North Westerly - PD 2nd Review

To: John Prestwich, PCS Group
From: Aly Burkhalter, Senior Planner
Date: August 16, 2024
Re: PD-001700-2024 North Westerly - PD

2nd Review & Referral Comments

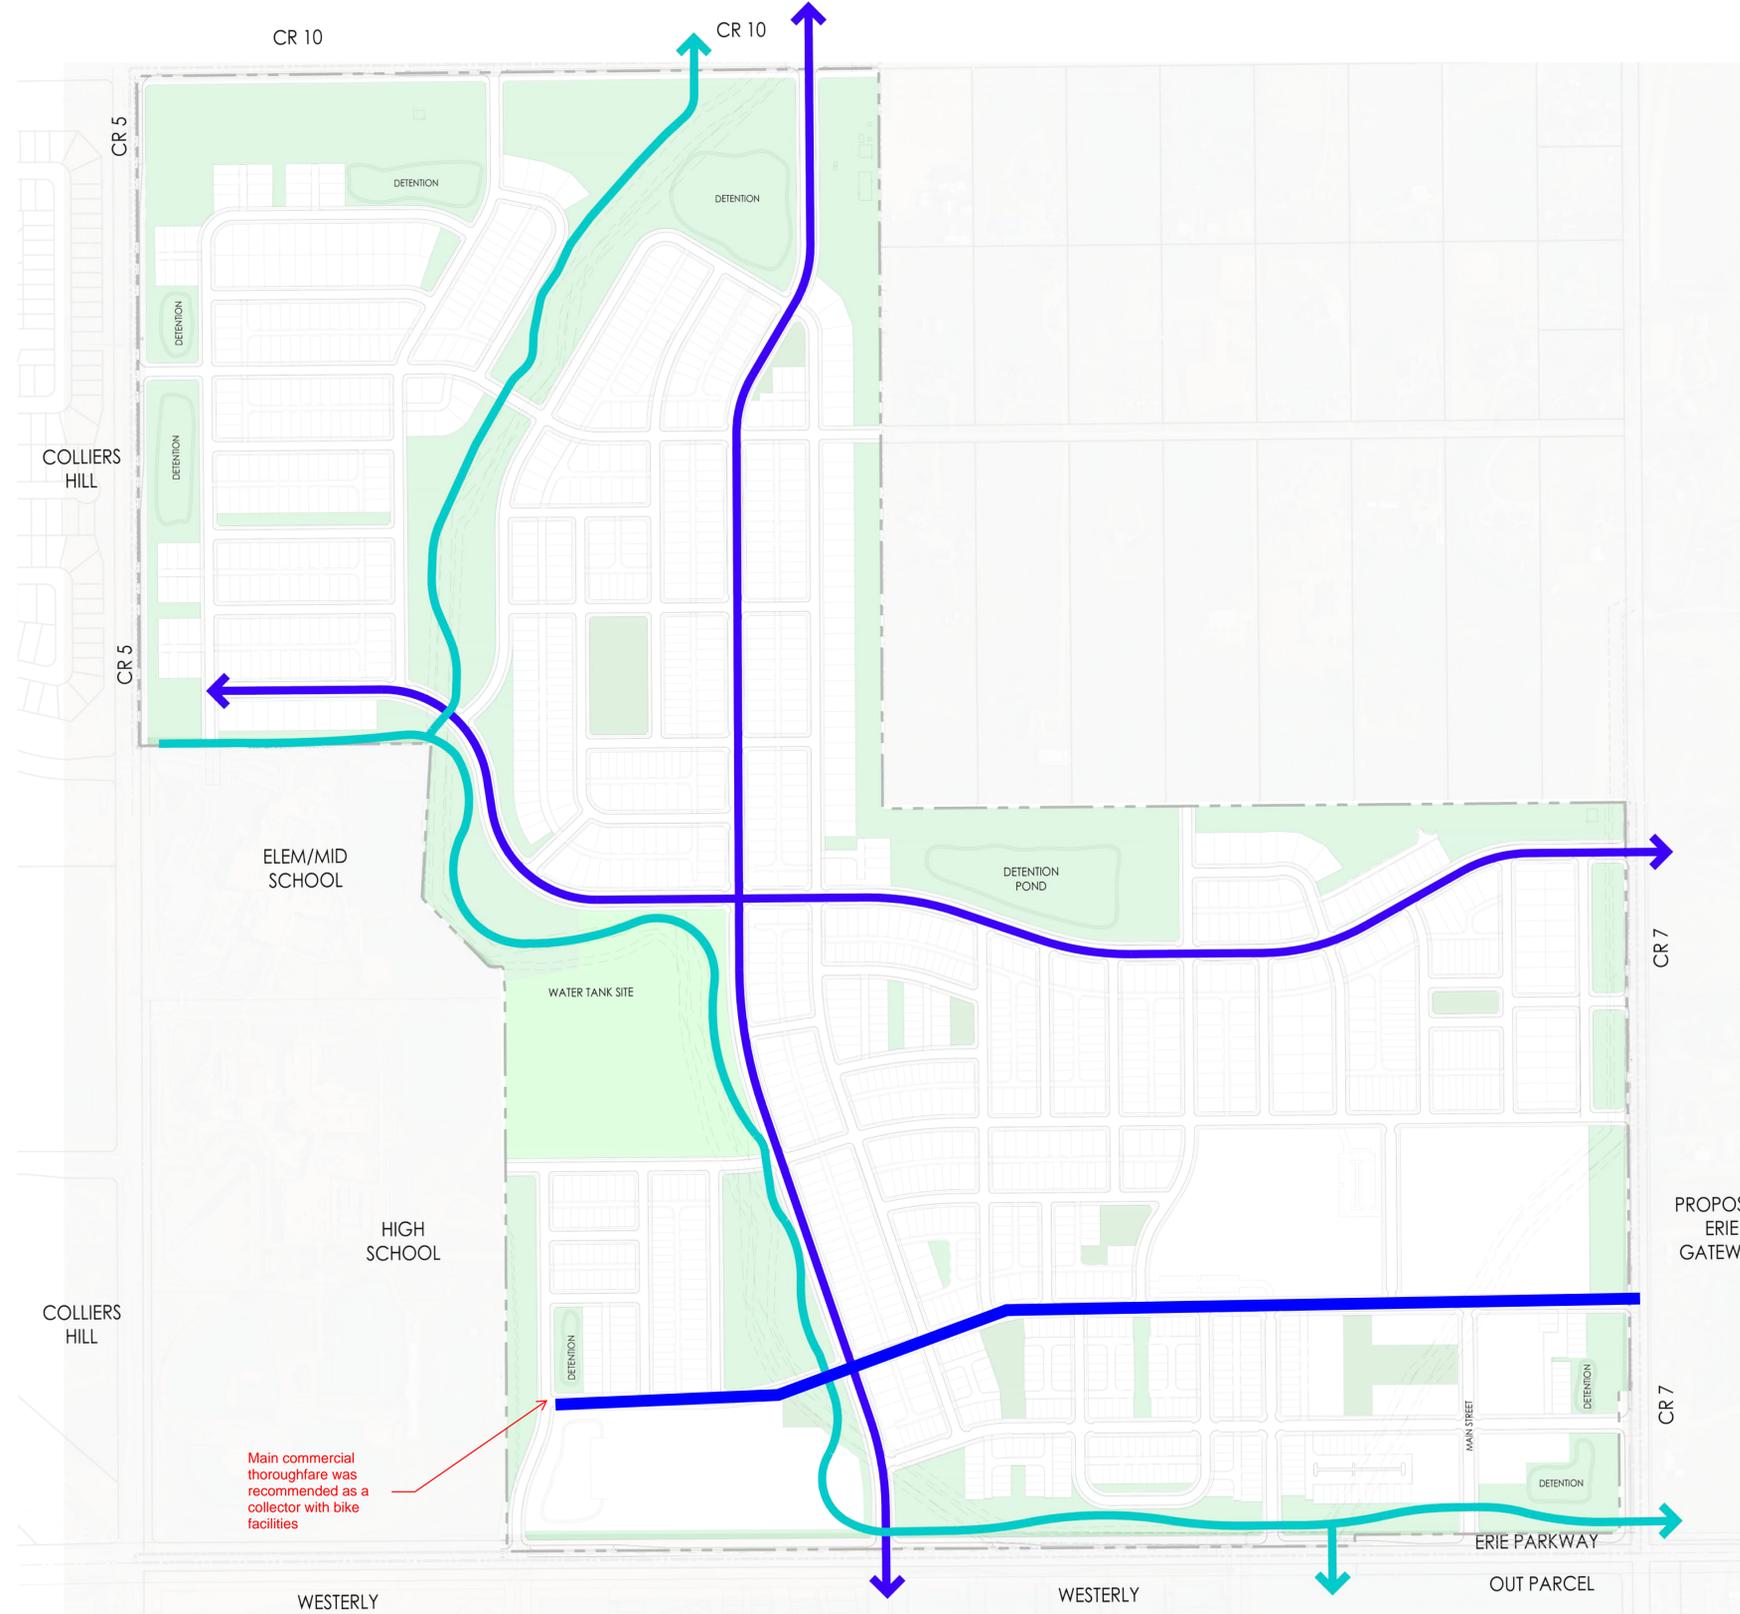
Comment #87: Please show building types from Concept Plan (single family detached front load, commercial, pocket park) faded back as underlay to Streetscape Plan on Sheet 14 so that staff can review streets in conjunction with land use.

Please update the legend with the street classifications and no width as described in the June 3rd memo. Legend should include:
a. Major Collector with Median
b. Minor Collector on a Designated Bikeway
c. Minor Collector
d. Local Street
Because the final street sections have not been determined, staff would prefer if the Streetscape Plan described street classifications without dictating widths. Street Classifications are determined by the AADT. The mark ups on Sheet 14 show what staff believes could be minor collectors based on adjacent land uses. Staff recommends the applicant work with their traffic consultant to determine the AADT of what was shown as green and light blue streets on the Streetscape Plan to determine if minor or major collector classifications are required.

SIGNAGE PLAN - OVERALL PHOTOMETRIC PLAN

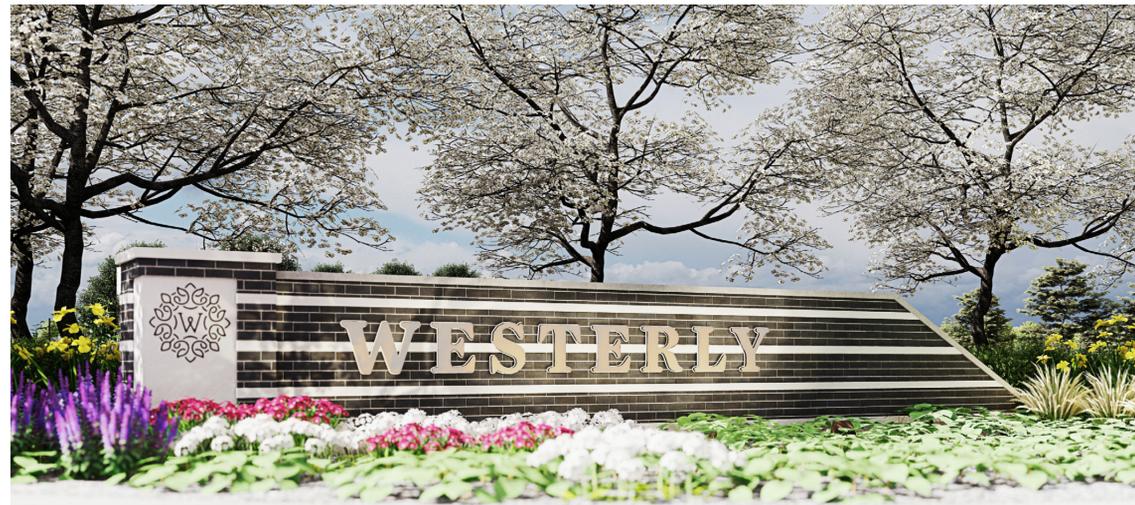
New Comment #126: Please provide a key map of planned Monument Signs. Per UDC, only one monument sign per street frontage is allowed for each development. If multiple monument signs are desired along Erie Parkway, a monument sign plan shall be provided in the PD Development Guide.

New Comment #128: [Sheet 17 Overall Lighting Plan] If you are using the same fixtures of the existing Westerly neighborhood. Please provide a scaled fixture design with height label.

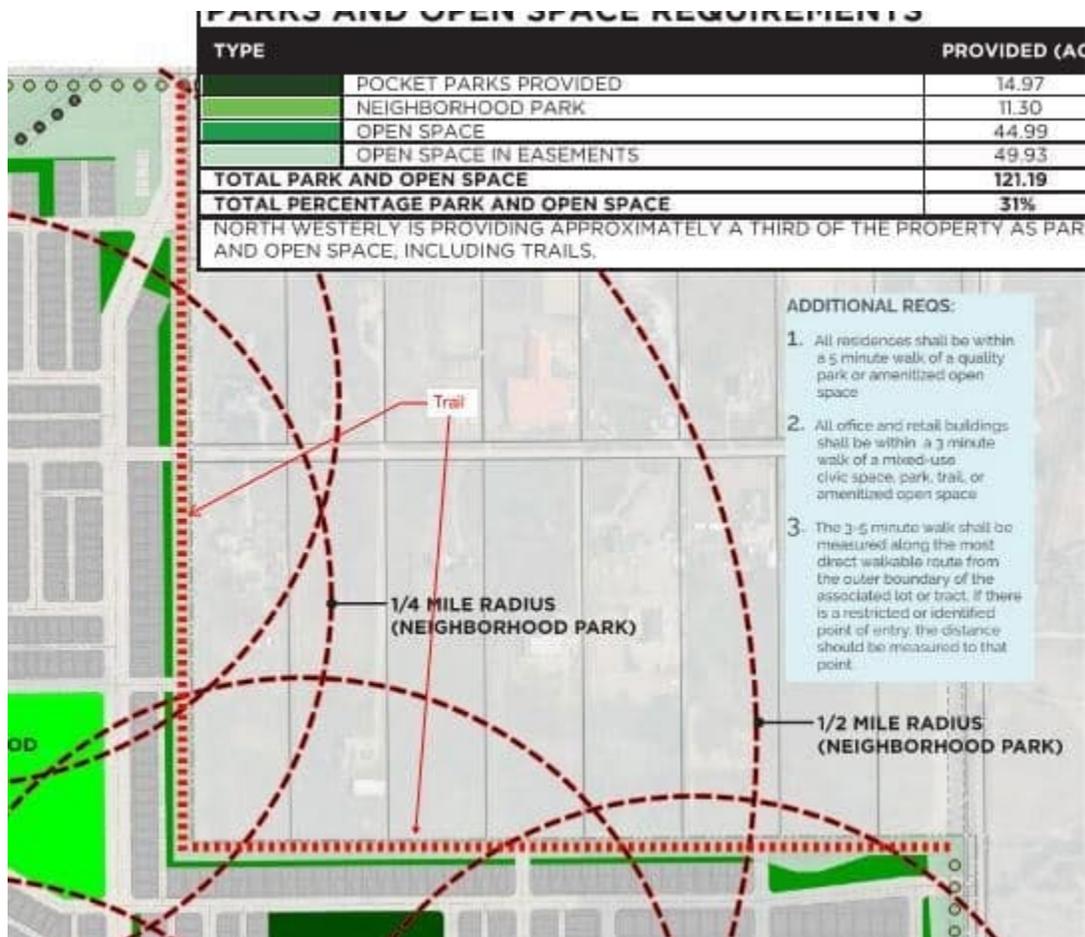
4. Provide an east/west trail connection from the Flora View Drive Intersection to the Neighborhood Park. See below.

Response: This trail connection has been provided.
